Date: May 23, 1997
Refer to: EM/ER:97-197

SUBJECT: MODIFICATIONS TO DRILLING PLAN FOR PRS 16-021(c)

RFI Phase II Sampling—16-021(c)

Enclosure: (1) Figure 5.2.11.2.1-1

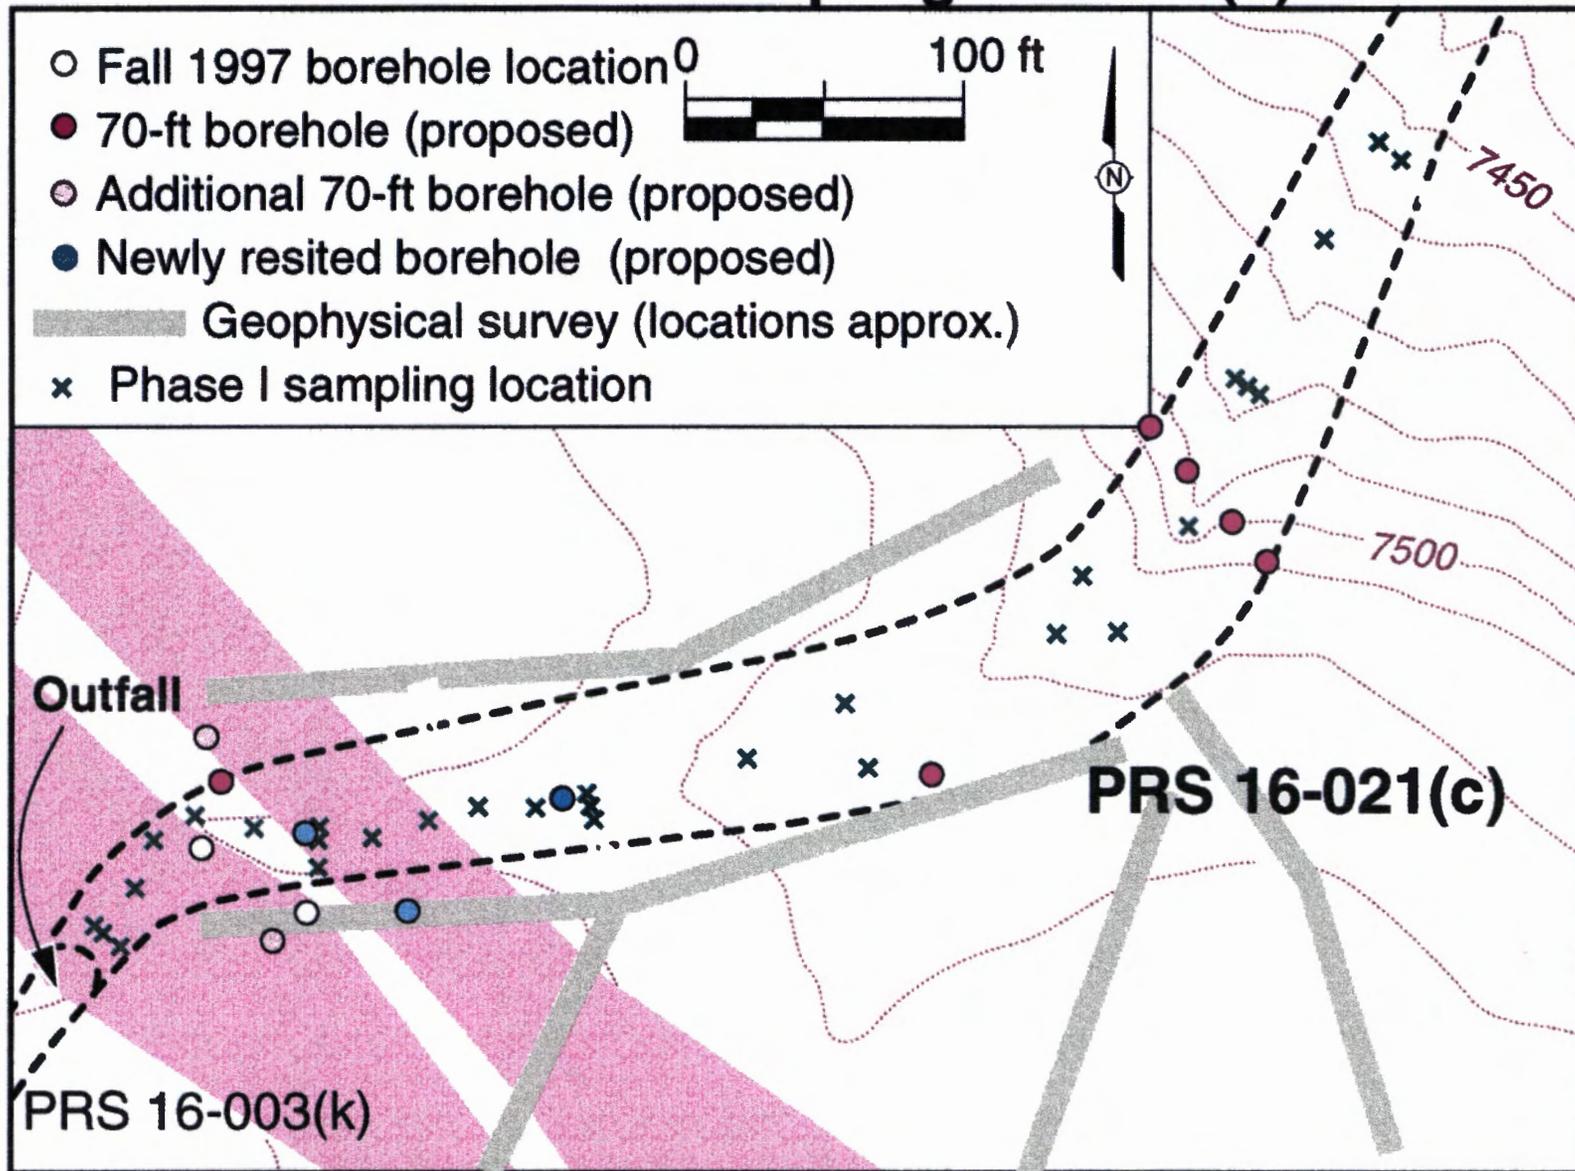
- The next three boreholes drilled at PRS 16-021(c) will be to a depth of at least 70 ft. This depth is greater than that outlined in the SAP. Such a depth is needed to understand the nature and extent of contamination in the deep surge beds.
- The next borehole that intersects a contaminated surge bed at a depth of 60-70 ft will be drilled to at least 85 ft. Three clean 5 ft intervals beneath the contaminated 60-70 ft-depth surge bed will be analyzed. These data are beyond what is outlined in the SAP. These additional samples are needed to understand the nature and extent of contamination in the vertical direction.

- The locations of the next 3 boreholes will be different than the locations shown on Figure 5.2.11.2.1-1 of the SAP. New proposed locations are shown schematically on the enclosed figure. Final locations will depend on accessibility of individual locations to the drill rig and could be influenced by any new information learned from additional boreholes. These locations are designed to test the hypothesis that the geophysical anomalies indicate the locations of contaminated surge beds at depth.
